# CITY PLANNING COMMISSION

- APPLICATION:
1. Variance to waive the required four foot planter along C Street and relocate same planter on City right-of-way.
  2. Planning Commission determination of parking required for a warehouse/manufacturing use based on number of employees.

LOCATION: 1701 C Street

APPLC. NO. P83-057

# Exhibit C

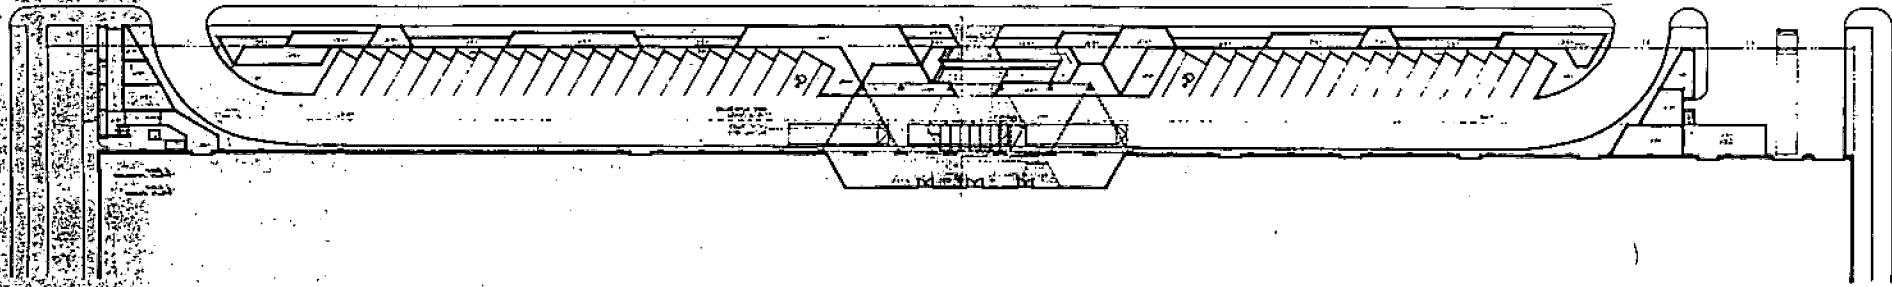
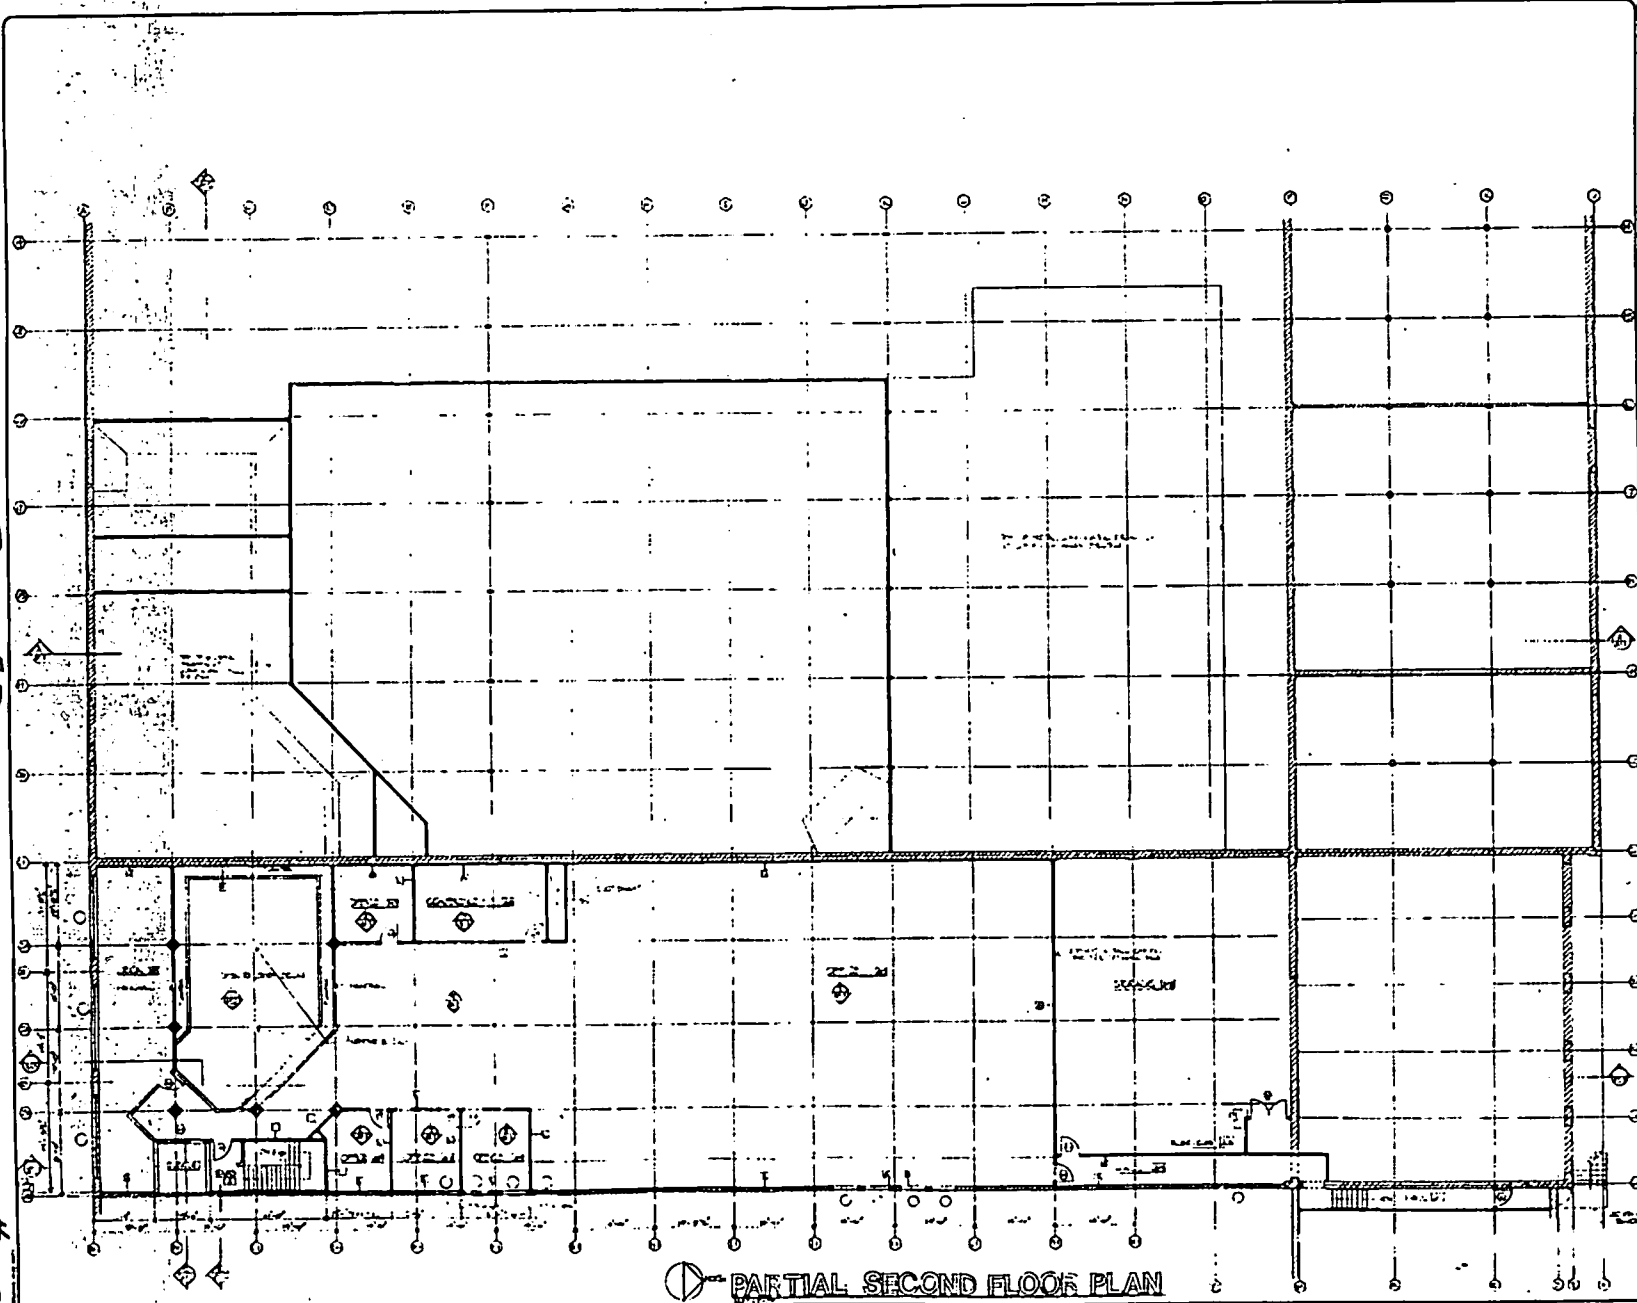
Staff, however, does feel that visibility may be hindered at the entrance and exit of the parking area due to the position of the raised planters as shown in Exhibit C. Staff suggests the applicant redesign and lower the raised planters at these locations. A detailed landscape, shading and irrigation plan must be submitted for staff review and approval prior to the issuance of building permits. In addition, a revocable permit from City Engineering Department will also be required before the improvements can be placed in the City right-of-way.

3. The City Traffic Engineer reviewed the proposed plans and had the following comments:
  - a. Minor adjustments in driveway design and curve required - there is a maximum 4% grade approach within 20' of public right-of-way.

- b. Eliminate illegal and hazardous "back-in" loading operation at 16th on C Street.
  - c. Lower planters at exit driveway for visibility.
4. Staff feels that a reduction in the required number of parking spaces for the warehouse use is justified due to the small number of people (30) that will actually be in the warehouse. Five people will be employed in the remodeled warehouse when it opens. The additional 25 people will be added in two years to operate the new almond processing line. The applicant will provide 98 parking spaces for the warehouse processing area. Based on the evidence submitted, staff believes the reduction of parking spaces for the warehousing/processing operation will not impact the on-street parking and will be adequate for the use. (See Exhibit A).

2. A revocable permit shall be obtained from City Engineering in order to place required landscape planter in the City right-of-way.
3. The applicant shall redesign the raised planters near the driveways on "C" Street, to mitigate the visibility concern. Revised plans shall be reviewed and approved by the Planning Director.

4. Applicant shall make necessary driveway modifications at the "C" Street parking area to the satisfaction of City Traffic Engineering.
5. Applicant shall provide for a minimum four foot wide planter landscaped in screening shrubs along property lines adjacent to the public streets at the 17th and "D" Street parking area (See Exhibit F). Landscape and irrigation plans shall be reviewed and approved by staff prior to building permit approval.
